Re: 361 Hanover st Development

Re: Zoning meeting Dec 16th, 2024 361 Hanover St For public record/ In favor

Re: 361 Hanover Street proposal and request for zoning relief

Figure 1: Current view from Rock Street Park. Note one can see the Pearl and residential homes.

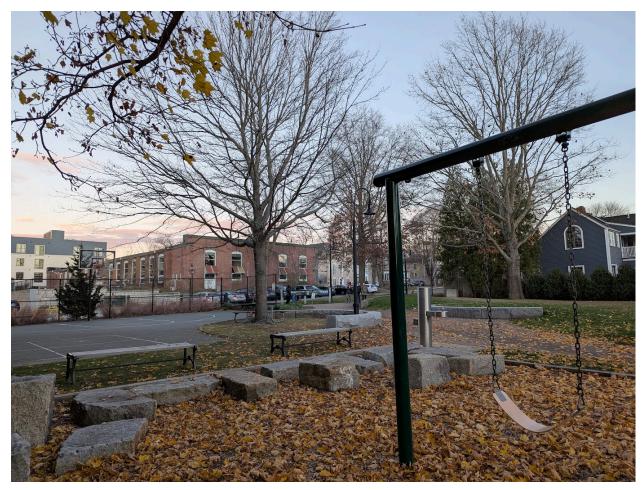
The out of character nature of this building adversely affects the quality of the greenspace for all our neighbors in Islington Creek. Few homes in Islington Creek have yards, so Rock Street Park is the only green space many of us have. This structure would loom over the park blocking sky views, increase flooding in the park and surrounding streets, potentially create wind tunnels and diminish the open-air feeling the park provides so many of us. Also, from the park one is able to clearly see one of the most iconic buildings not just in Islington Creek, but all of Portsmouth: The Pearl. In Figure 2, one can imagine how much the sky and views would be blocked with a towering, 5 story building there.

Concession Requested: We would like to see Building A provide a graceful transition from the four story heights of the other buildings on Foundry Place to the parks, residences, and one story industrial buildings (and certainly not be taller than the parking garage). We would like to see Building D not exceed the height of any existing residential building on Hanover Street (the current tallest residential building is 349 Hanover Street)
